Project: Iowa Army Ammunition Plant  
Equipment: EM-61 (1.0x0.5m)  
Grid/Location: GPO

## URS RESPONSE TO USEPA AND US ARMY COMMENTS

### DRAFT GPO TECHNICAL MEMORANDUM MILITARY MUNITIONS RESPONSE PROGRAM AT IOWA ARMY AMMUNITION PLANT

VIBRATION TEST (CABLE SHAKE) (Figure C-1)

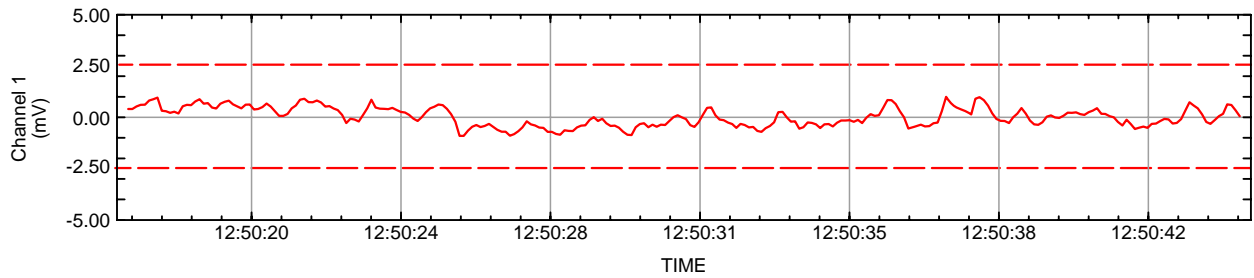
**Comment 36.** Appendix C, Page C-1, Figure C-1 - This chart would benefit from the addition of red dashed lines indicating the boundaries of the "Acceptable Range".

**Response:** Agree. The figure will be revised as suggested.

Figure C-16 Approved: \_\_\_\_\_

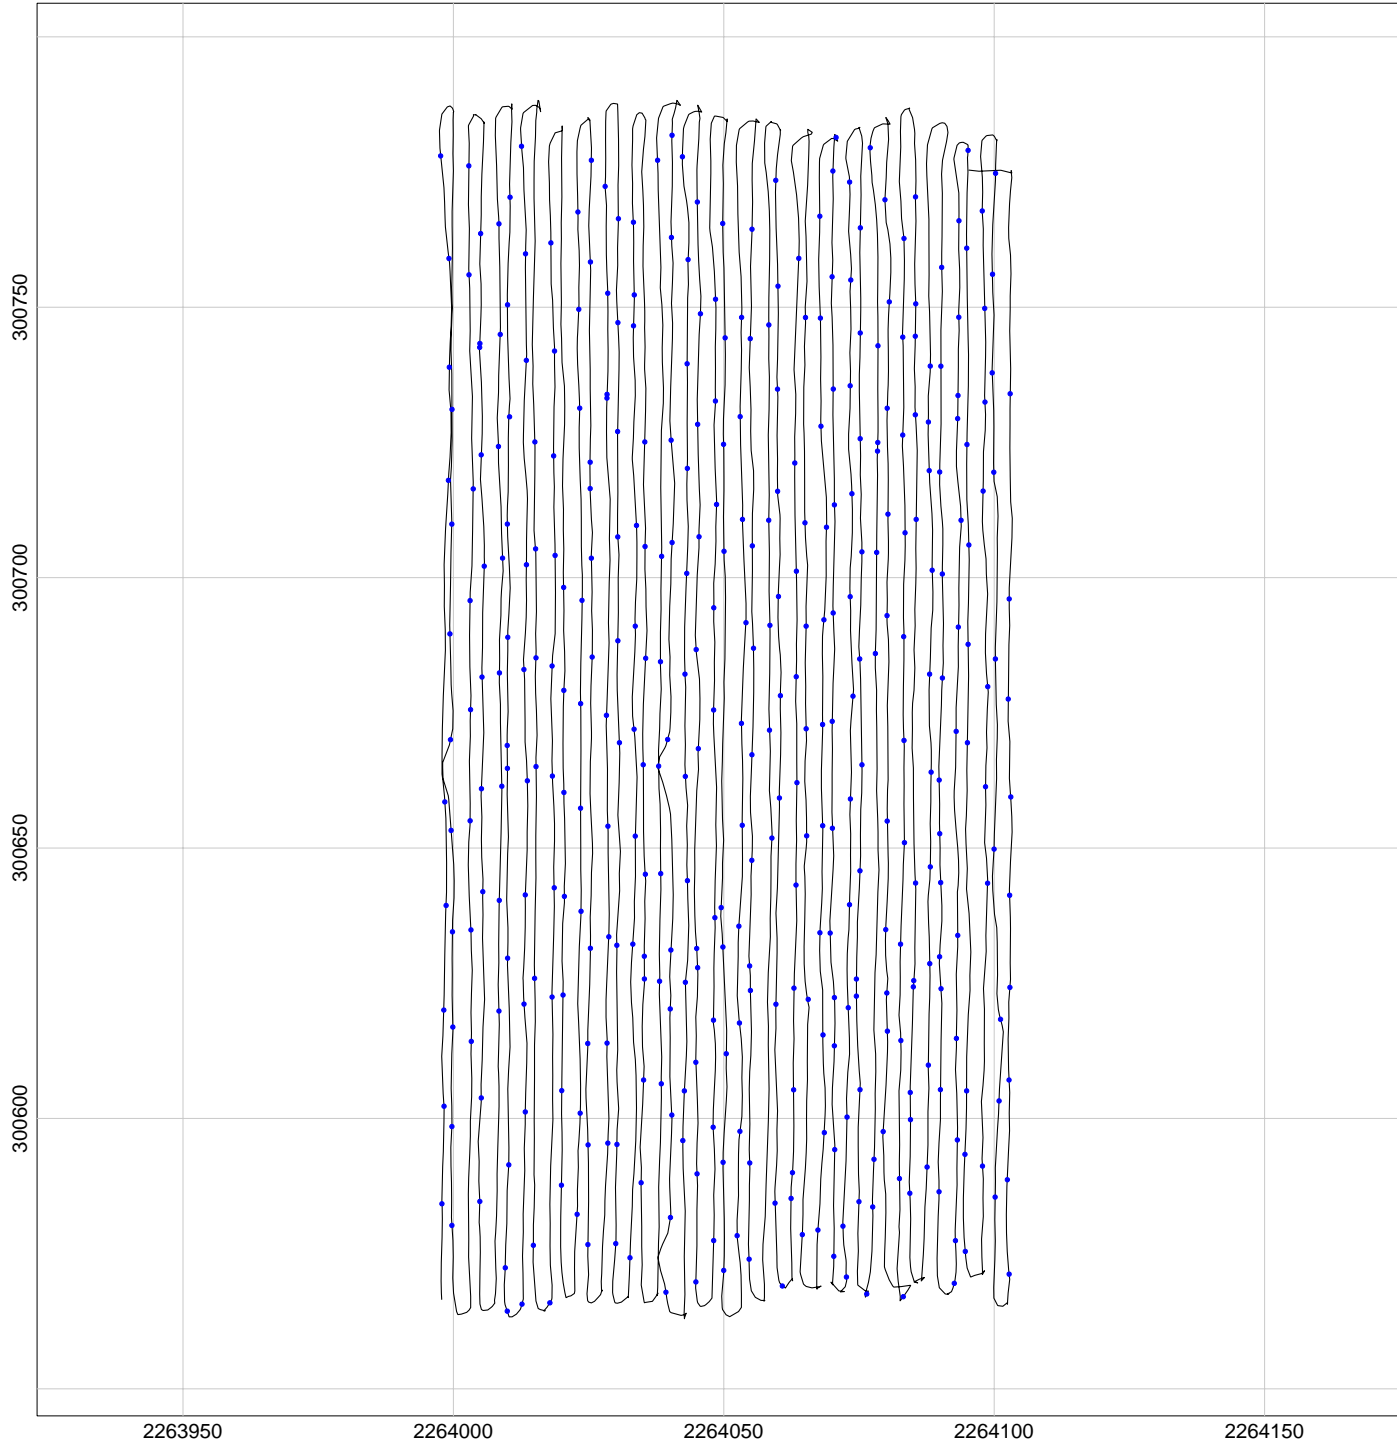
**Comment 41.** Appendix C, Page C-19, Figure C-10 - There should be a tolerance listed here for the maximum permitted separation. What percentage of data exceeding the maximum spacing is acceptable?

**Response:** Agree. Based on the GPO results, the maximum permitted separation tolerance limit for line separation for the production geophysical survey will be 1.0 foot with 20% allowable percentage of data exceeding the maximum spacing.

Figure C-18 Approved: \_\_\_\_\_

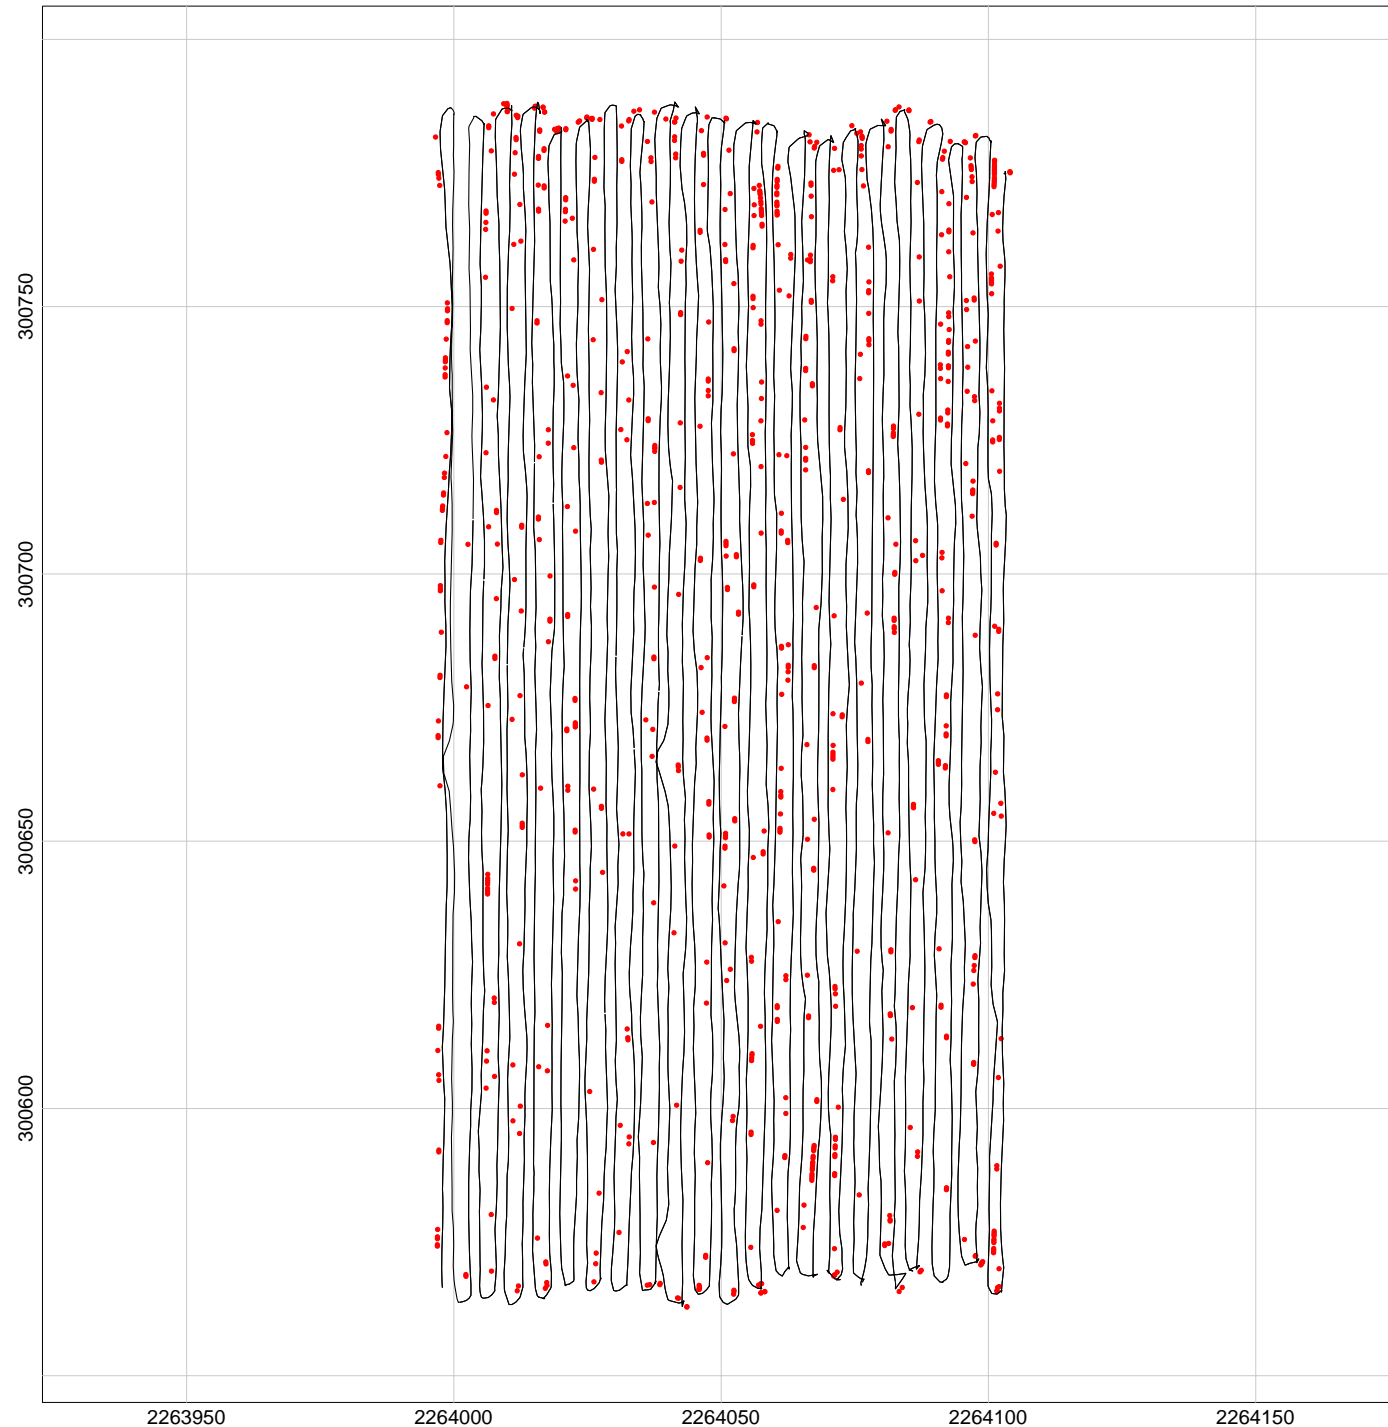
**Comment 42.** Appendix C, Page C-21, Figure C-11 - Is the tolerance here 1.5 mV? In what Channel?

**Response:** Agree. Channel 1 data is displayed. Based on the GPO results, the noise threshold tolerance is 1.5 mV. For the production geophysical survey, with an acceptable out of tolerance of 20% of the data. This information will be added to the figure for clarification.

Figure C-20 Approved: \_\_\_\_\_

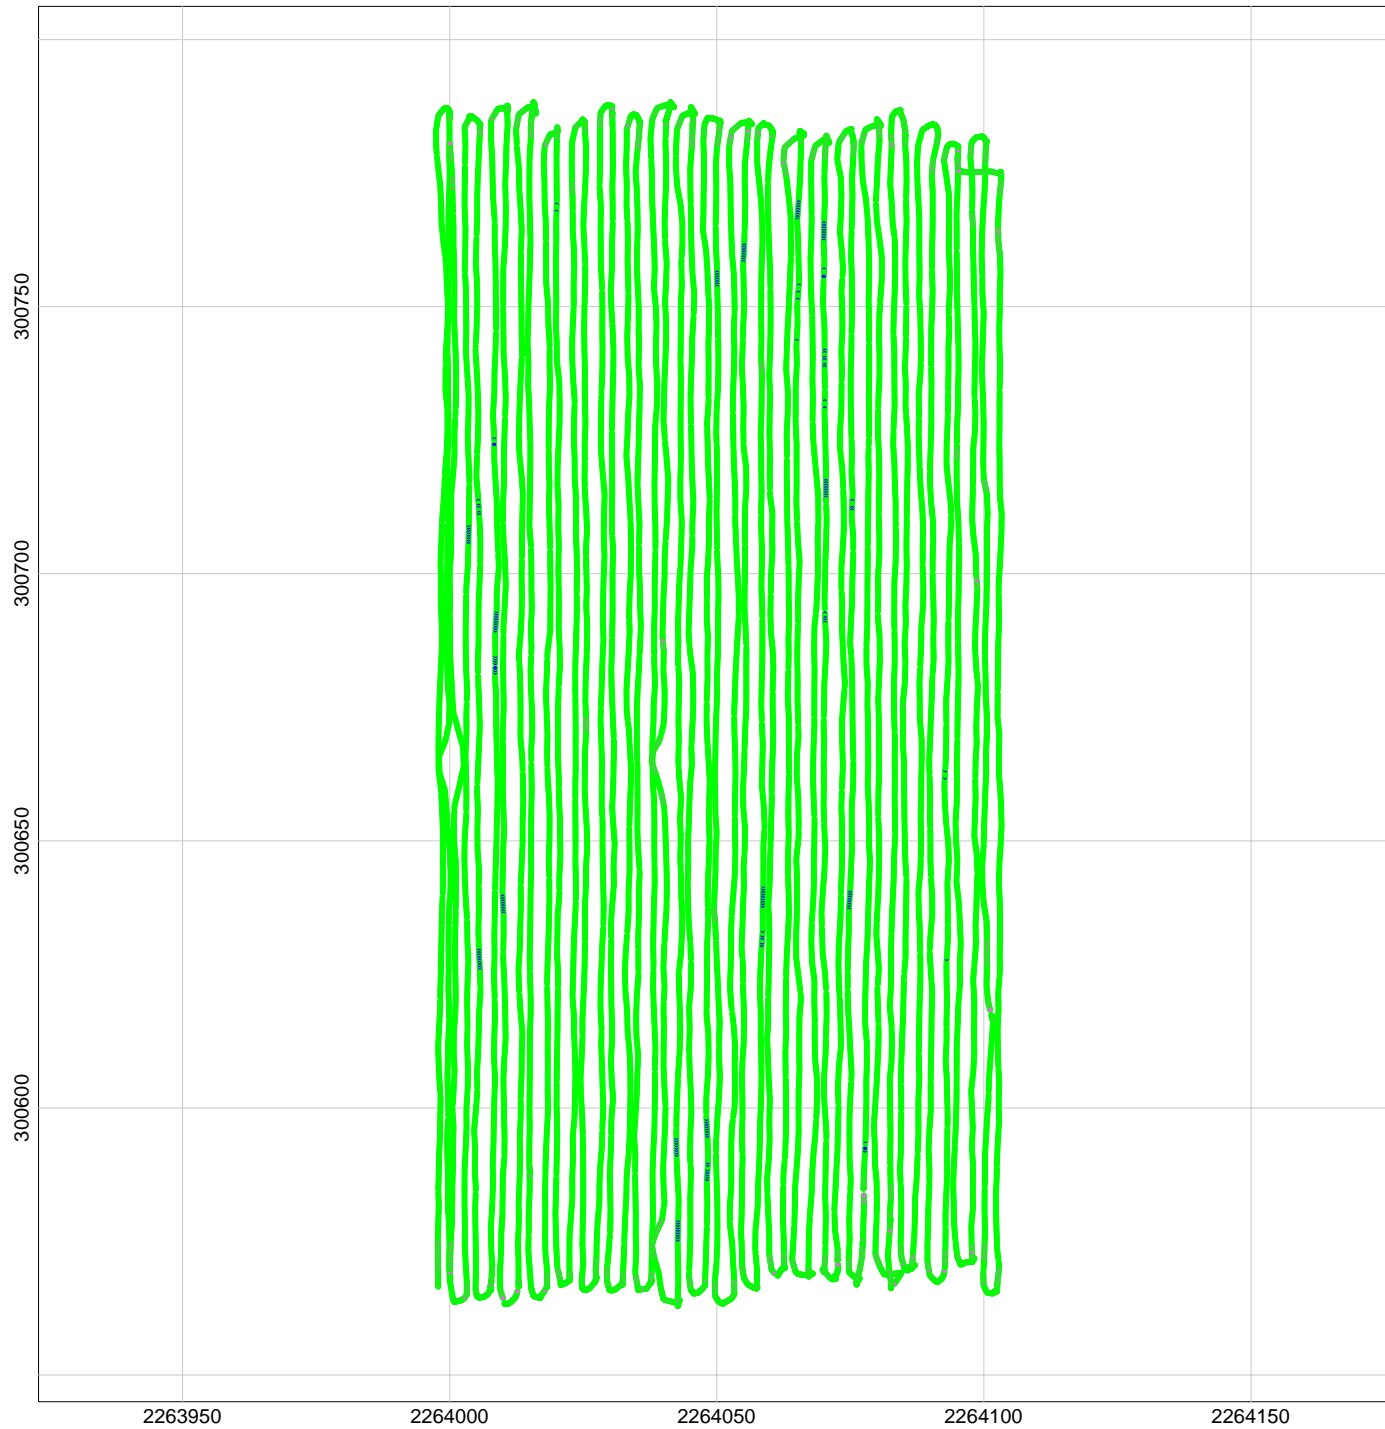
**Comment 43.** Appendix C, Page C-23, Figure C-12 - The implication for data collected at a velocity below an acceptable number is that an incorrect latency will be applied, negatively affecting the positioning of the target. What are the upper and lower limits of acceptable velocity? What percentage of out-of-tolerance data is acceptable?

**Response:** Agree. The text will be revised to indicate that based on the GPO results, the upper limit of acceptable velocity for the production geophysical survey will be 3.0 Mi/h with an acceptable out of tolerance of 20% of the data.

Figure E-3 Approved: \_\_\_\_\_

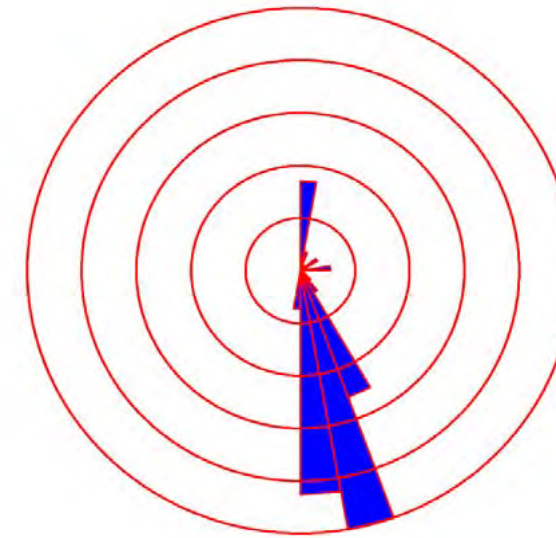
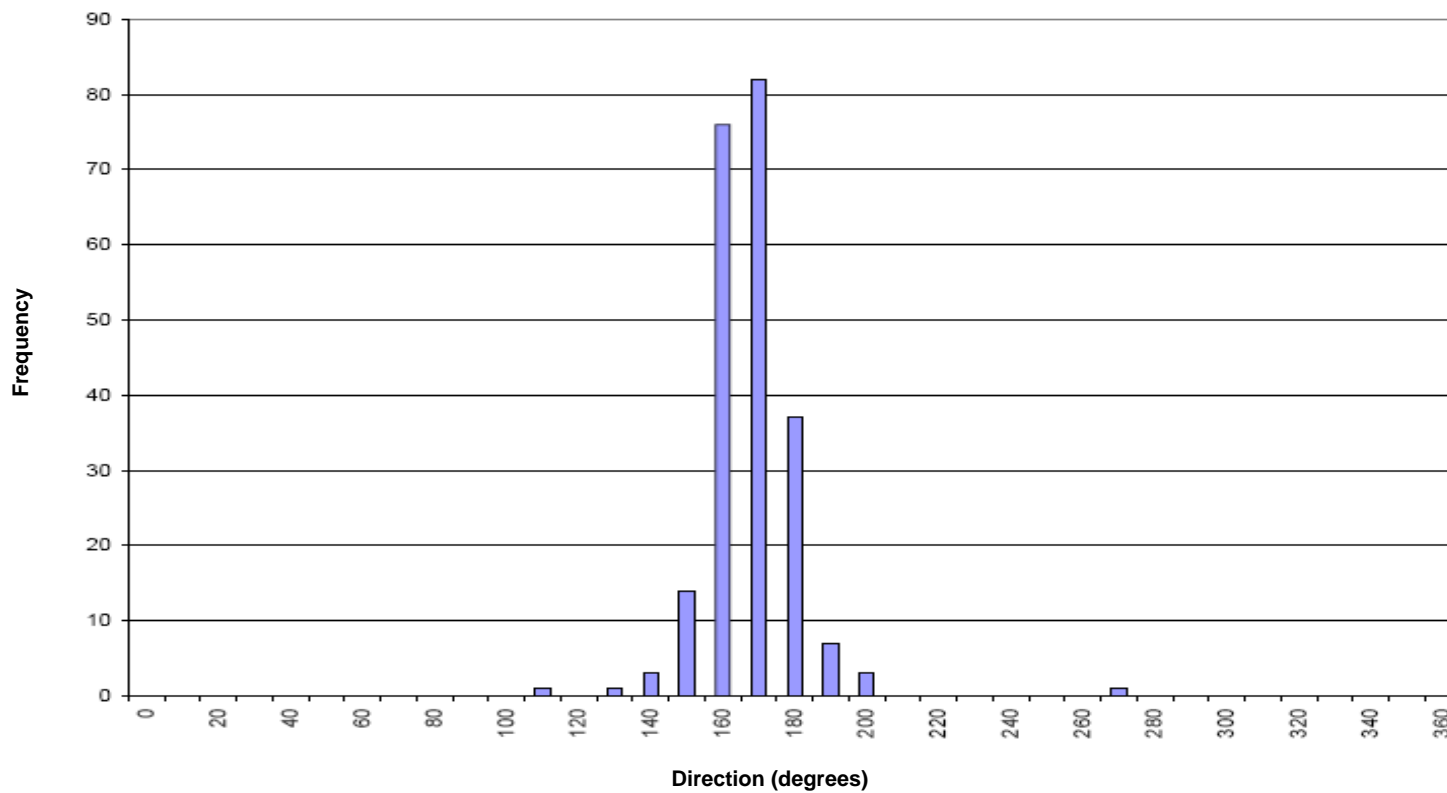
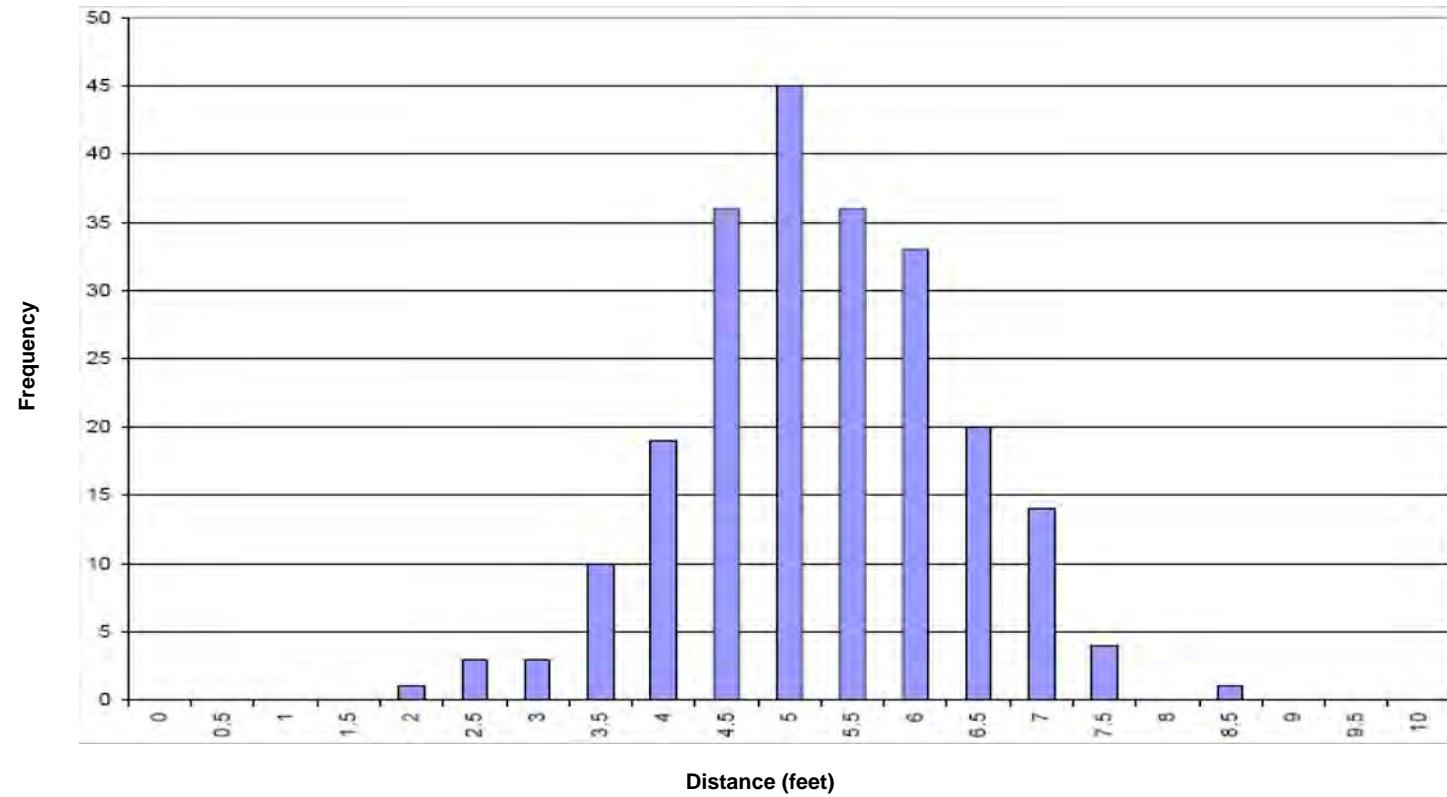
**Comment 28.** Section 5, Page 5-1, Reacquisition Results, paragraph 3 - The positional shift looks like it would work well at the Central Test Area, where a normal distribution can be seen in Figure E-3, but Figure E-6 shows a different story for the Line 6 Ammo Production MRS. Assuming Figure E-6 shows locations that have not been adjusted 5 feet, 53% would still lie outside of the 1-meter radius if adjusted by 5 feet. Please discuss.

**Response:** Agree. See response to Comment number 3. If one assumes that the MKM base station remained at the same location for the duration of data acquisition, the offset distance and direction should be similar for Line 6 and the CTA. It is possible that the density of anomalies located within Line 6 may have attributed to locating a target not associated with the selected/intended target
